# SERVICE BULLETIN

SERVICE BULLETIN NO: 180

## FLIGHT CONTROLS - HORIZONTAL STABILIZER - INSTALLATION OF A TRIM WARNING SYSTEM

Revision 1 to this Service Bulletin adds and corrects part numbers and revises the installation/ test procedure.

Expansion Bush and Weight-On-Wheels (WOW) Switch S101 Installation  
 Figure 1

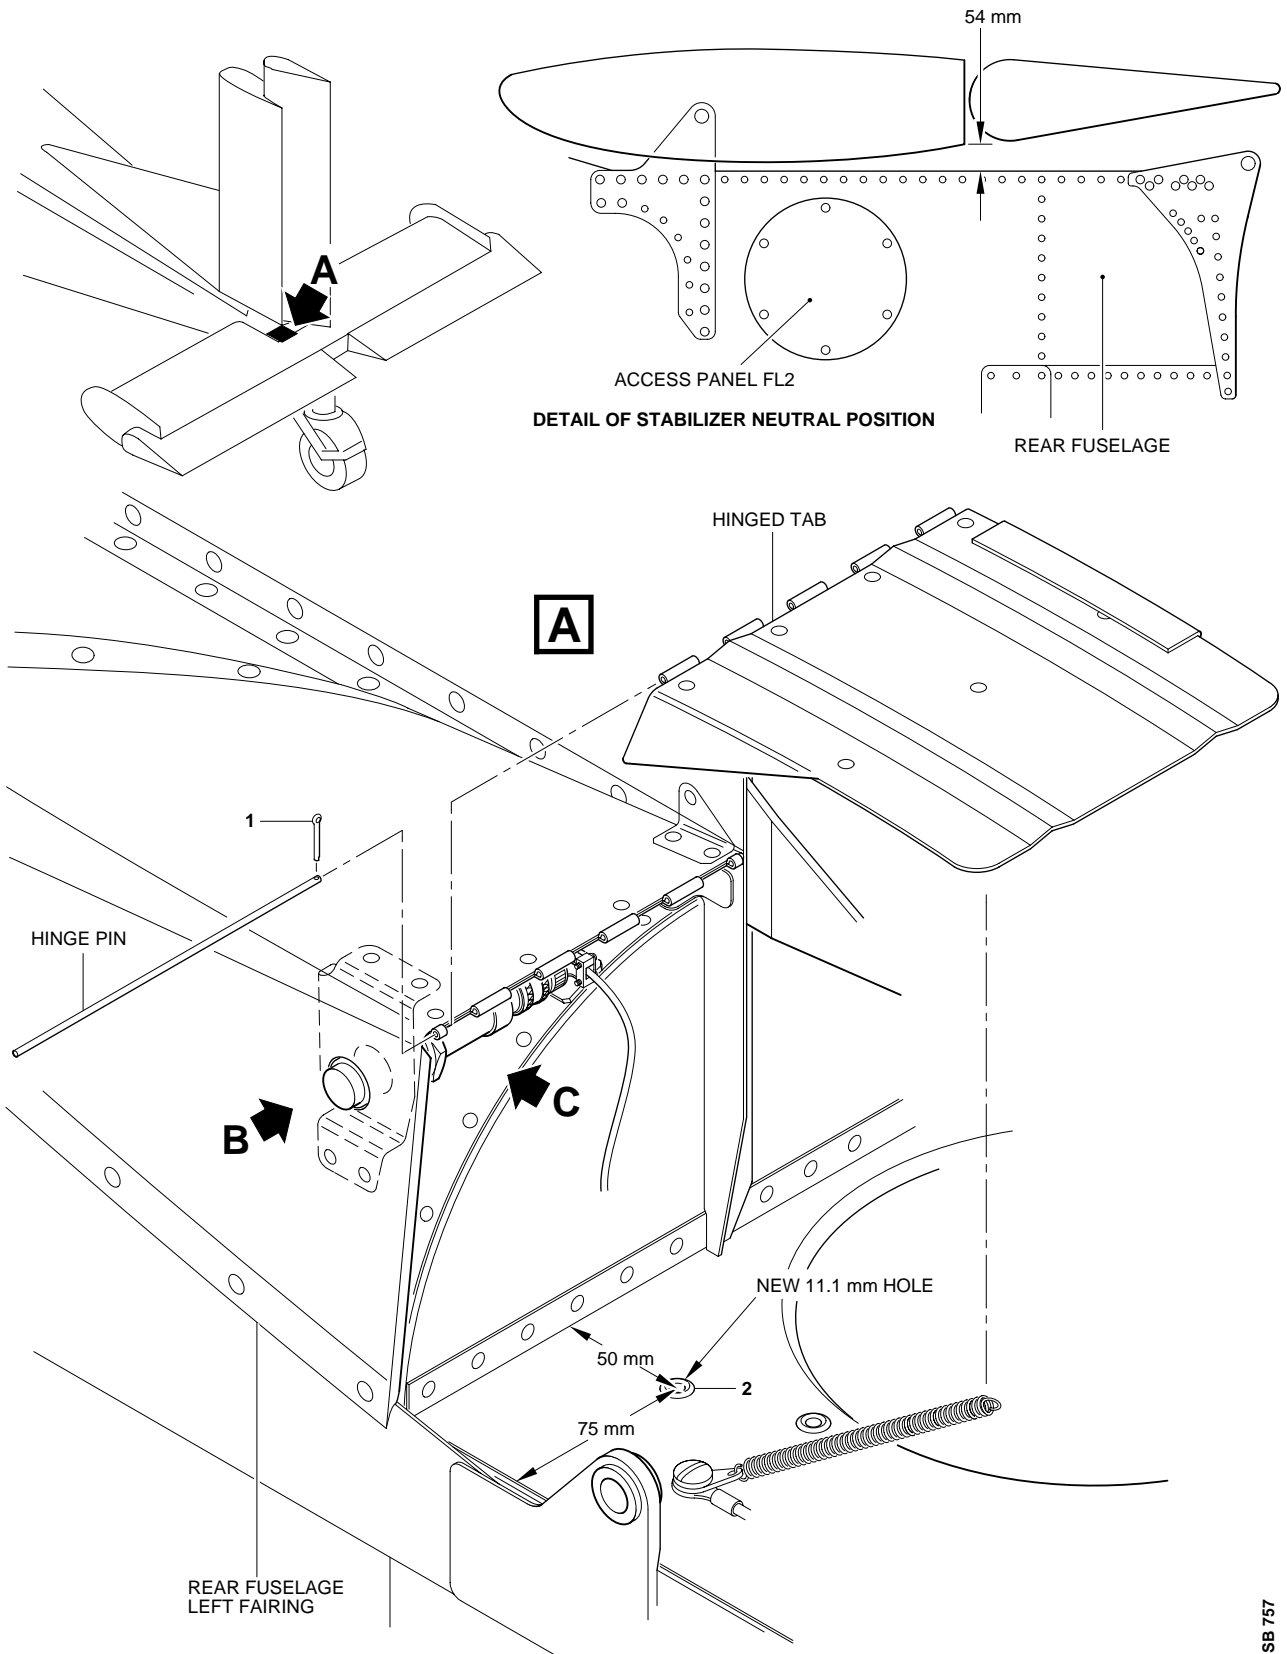
- (1) Install the weight-on-wheels (WOW) switch S101 and its related cam (expansion bush) as follows (Ref. Fig. 1):
  - (a) Remove the V-strut front fairing (6).
  - (b) Attach the support angle (5) to the V-strut fitting (10) as follows:
    - (i) Remove the two nuts (4) and the two washers that attach the V-strut fitting (10) to the aircraft structure at the bottom of Frame 2.
    - (ii) Discard the two washers .

- (iii) Attach the support angle (5) to the V-strut fitting (10), with the two new (thinner) washers (3) and the two nuts (4).
  - (iv) Remove the nut (7) and the washer (8).

- (v) Discard the washer (8).
  - (vi) Install the new (thinner) washer (8) and the nut (7)
- (c) Put the rod (11) in the expansion bush (2).
- (d) Install the washer (12) and the nut (13).

- (e) Tighten the nut (13), but do not make the bush expand at this time.
- (f) Measure the internal diameter of the V-strut spigot (14). If the internal diameter of the spigot is 18 mm, install the sleeve supplied.

- (g) Put the expansion bush (2) and rod (11) assembly in the V-strut spigot (14) as far as possible.
- (h) Make sure that the cam of the expansion bush (2) is approximately at the position shown.

- (i) Tighten the nut (13), but only sufficiently to keep the expansion bush and rod assembly in position.
- (j) Install the WOW switch (1) in the support angle (5), make sure that it is in a position that lets it touch the start of the expansion bush cam (2).

- (k) Tighten the nut (13) (max torque 5 Nm (44 lbf in.)) to keep the expansion bush (2) in position.
- (l) Tighten the two locknuts of the WOW switch (1).

- (m) Make sure that after you tighten the two locknuts, the WOW switch (1) touches the expansion bush (2) (Ref. Fig.1) at the correct position.
- (n) Safety the two locknuts with lockwire (Material No. P02-001).

- (o) Drill an 8 mm hole at a position 20 mm to the right of the rear RH hole of the four holes which are for installation of ski equipment.
- (p) Install the grommet (15) in the new hole.

- (q) Put the WOW switch wire through the grommet (15).
- (r) Ground the WOW switch wire with the red identifier to the aircraft structure.
- (2) Put the horizontal stabilizer in the neutral (0) position.

Proximity Switch S100 Installation  
 Figure 2 (Sheet 1 of 2)

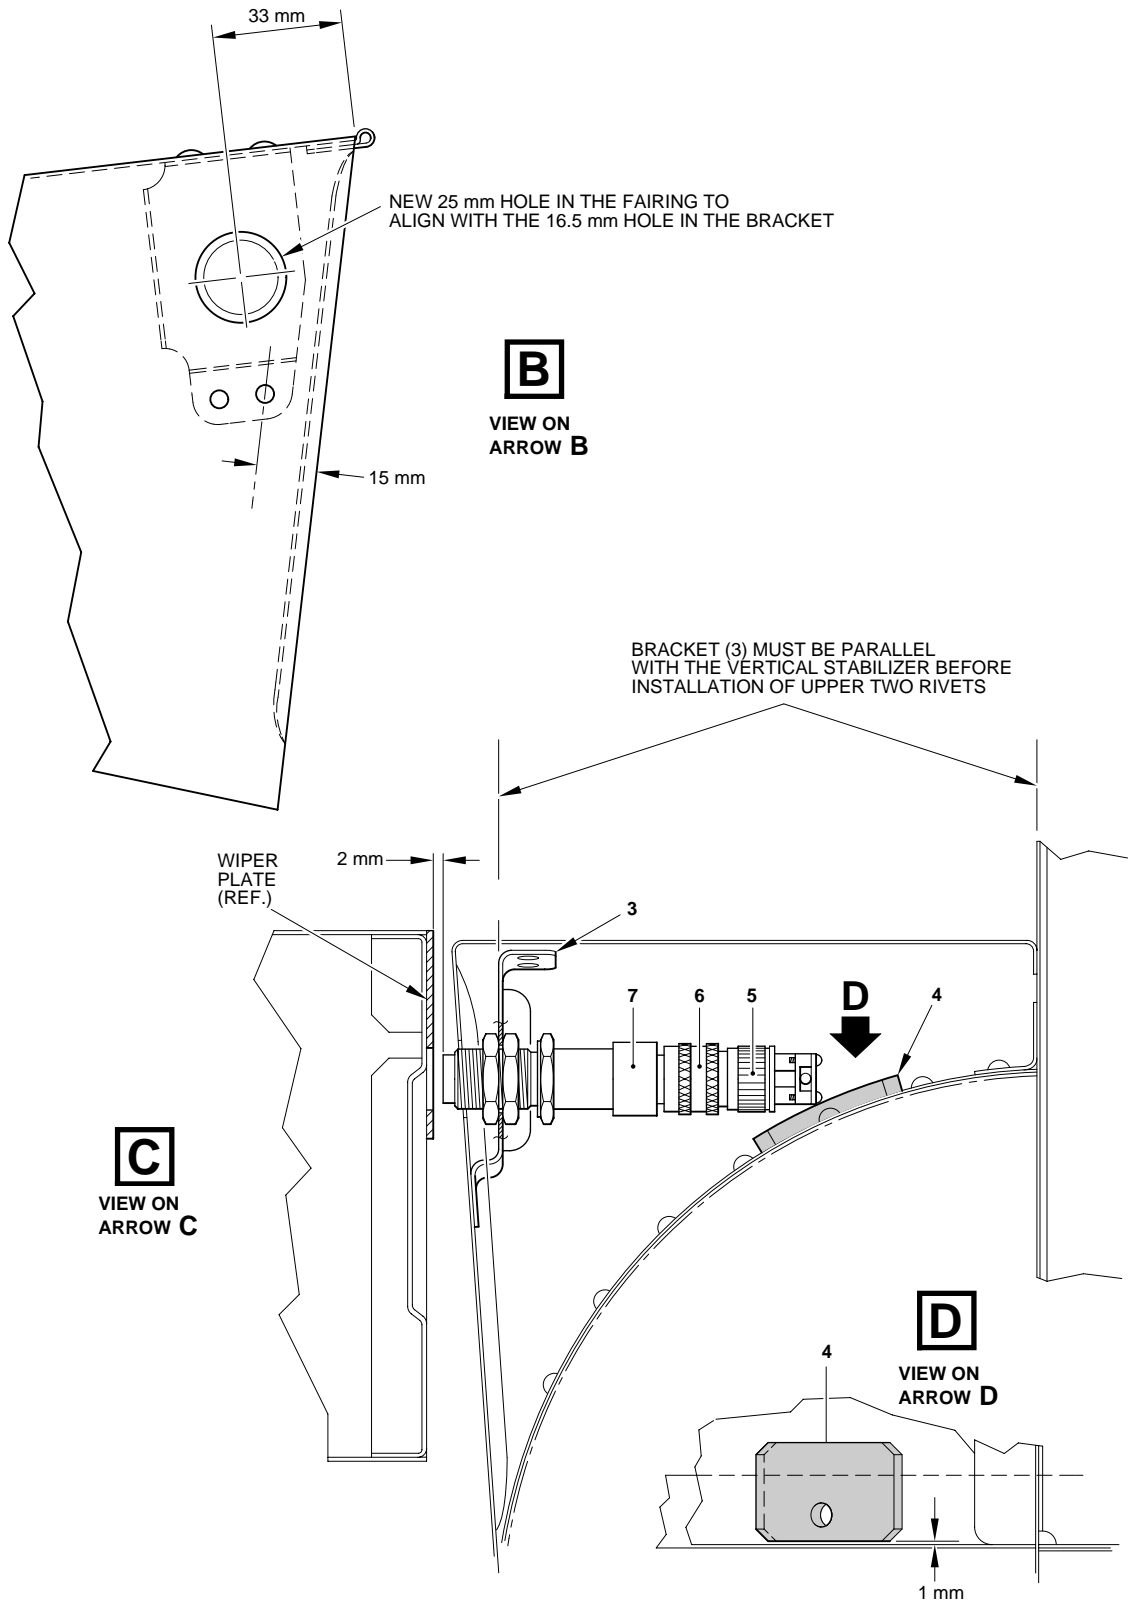
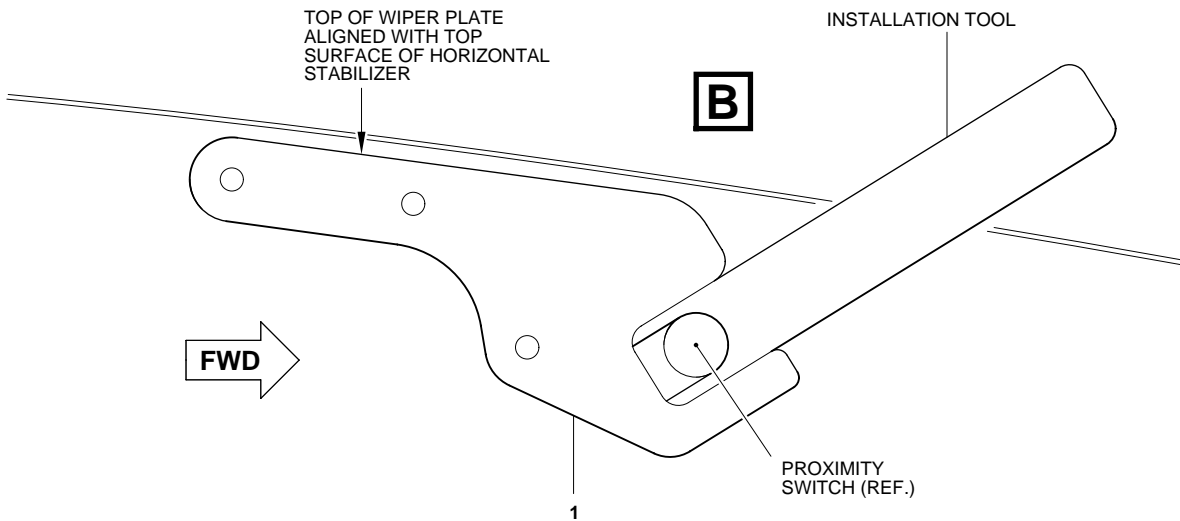
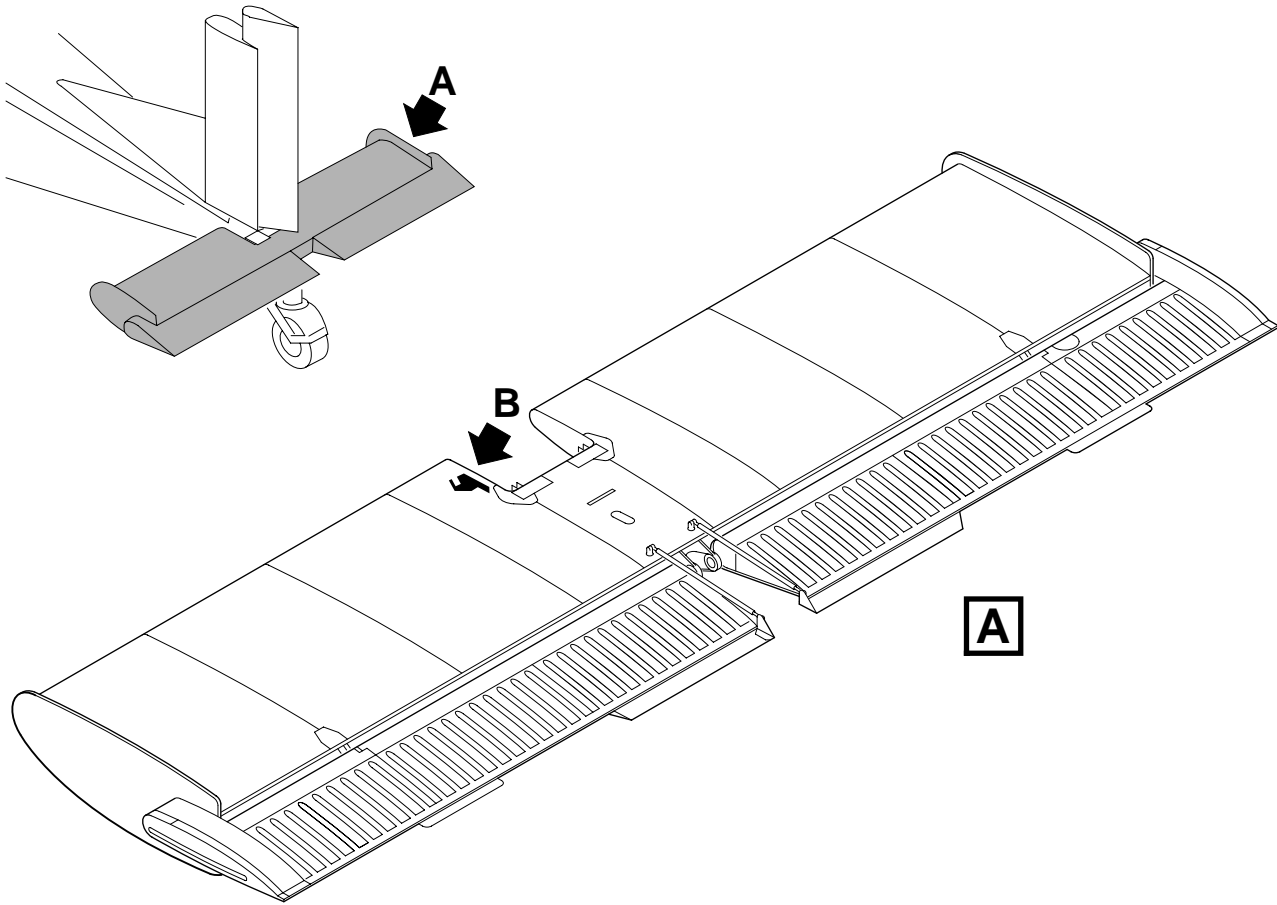
- NOTE:** The neutral position is when the vertical distance from the top edge of the rear fuselage to the trailing edge of the horizontal stabilizer is 54 mm (Ref. Fig. 2).

- (6) Install the proximity switch S100 as follows (Ref. Fig. 2):

- (a) Remove the hinged tab at the rear of the rear-fuselage left fairing.
  - (i) Open the hinged tab and disconnect it from its spring.
  - (ii) Remove and discard the cotter pin (1) from the inboard end of the hinge pin.

- (iii) Remove the hinge pin and the tab.
- (b) Drill the four 3,3 mm holes in the rear-fuselage left fairing
  - (i) Use the mounting bracket (3) as a template to drill the holes.

- (ii) Mark and drill the two 3,3 mm holes in the top of the rear-fuselage left fairing.
  - (iii) Mark and drill the two 3,3 mm holes in the side of the rear-fuselage left fairing.

- (iv) Install the placard S100 on the mounting bracket (3).
- (c) Install the proximity-switch mounting bracket (P/N: 116.40.06.120) (3)
  - (i) Hold the bracket (3) in position and install the two bottom rivets (P/N: 939.17.81.234).

- (ii) Make sure the bracket (3) is parallel with the vertical stabilizer and install the top two rivets (P/N: 939.17.81.234).
- (d) Mark and drill a 25 mm hole in the side of the rear-fuselage left fairing.

**NOTE:** The 25 mm hole in the side of the rear-fuselage left fairing must be aligned with the 16.5 mm hole in the mounting bracket (3) (Fig. 2).

- (e) Use contact adhesive (Ref. AMM 20-31-00 Item No P08-009) and attach the rubber protection plate (4) to the rear fuselage structure.
- (f) Connect the strain relief (5) and the wire W1C20 to plug P100 (6) (Ref. wiring data in step (12) and Fig. 7).
- (g) Connect the plug P100 (6) to the proximity switch S100 (7).

- (h) Install the proximity switch S100 (7) and set the clearance between the wiper plate and the proximity switch to 2 mm (0.078 in.).
- (i) Put the wires of the proximity switch rearward.

- (j) Tighten the two locknuts on the proximity switch.
- (k) After you have tightened the two locknuts, make sure the clearance between the proximity switch and the wiper plate is correct.

- (l) Safety the two locknuts with lockwire (Material No. P02-001).
- (m) Make a mark and drill a 11.1 mm hole in the structure (Ref. Fig. 2).
- (n) Install the grommet (6).

Wiper Plate Installation  
Figure 3

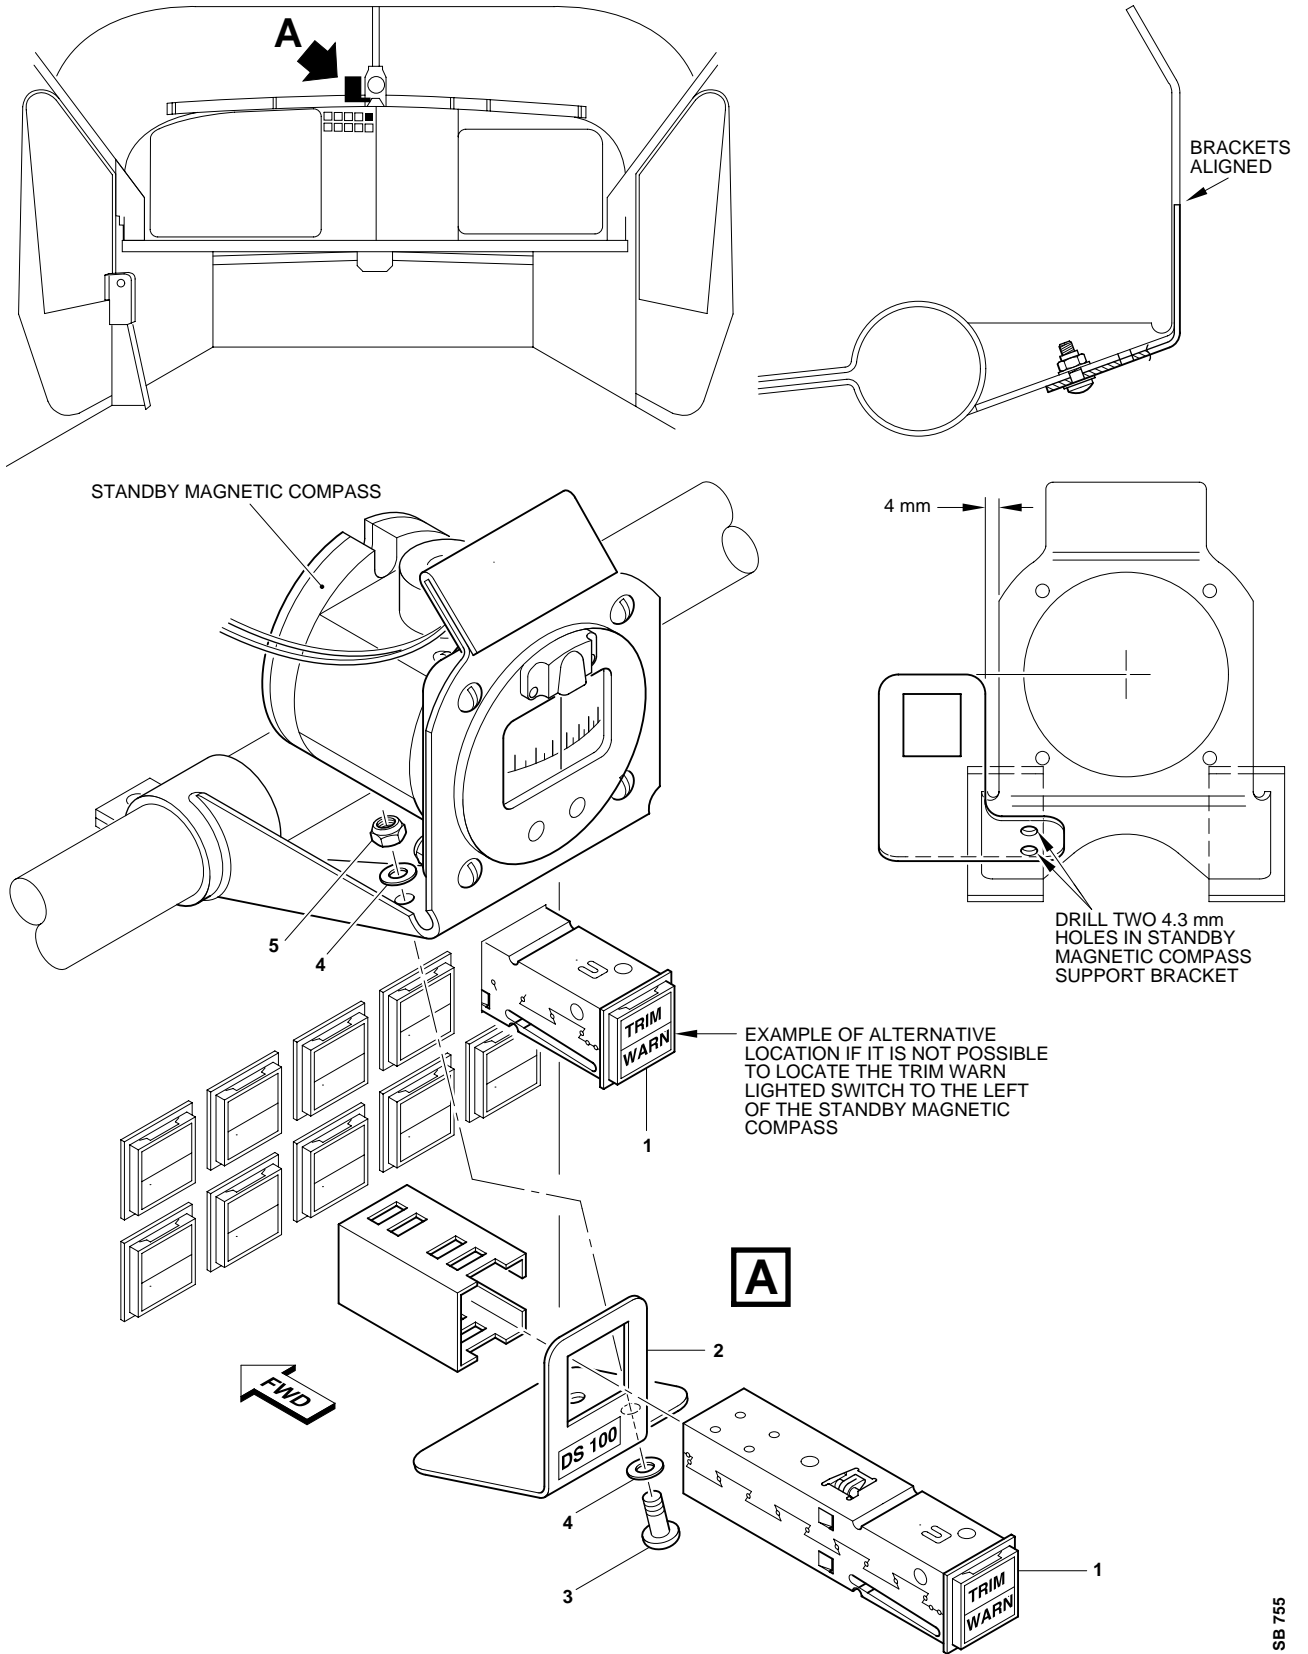
- (9) Install the wiper plate as follows (Ref. Fig. 3):
  - (a) Use the installation tool and put the wiper plate (1) in the correct position on the horizontal stabilizer.

- (b) Mark the location for the wiper plate on the horizontal stabilizer.
  - (c) Remove the horizontal stabilizer.
  - (d) Make sure that the wiper plate is in the correct position on the horizontal stabilizer.

- (e) Mark and drill three 4.3 mm holes.

- (f) Apply a thin layer of sealant (Ref. AMM 20-31-00, Item No. P08-020) to the interface of the stabilizer and the wiper plate (1).
  - (g) Use the blind rivets (CR3222-4-2) and attach the wiper plate (1) to the horizontal stabilizer.
  - (h) Make sure that the area is clean and clear of unwanted material.
- (10) Install the horizontal stabilizer (Ref. AMM Chapter 55-11-11, Page Block 401).
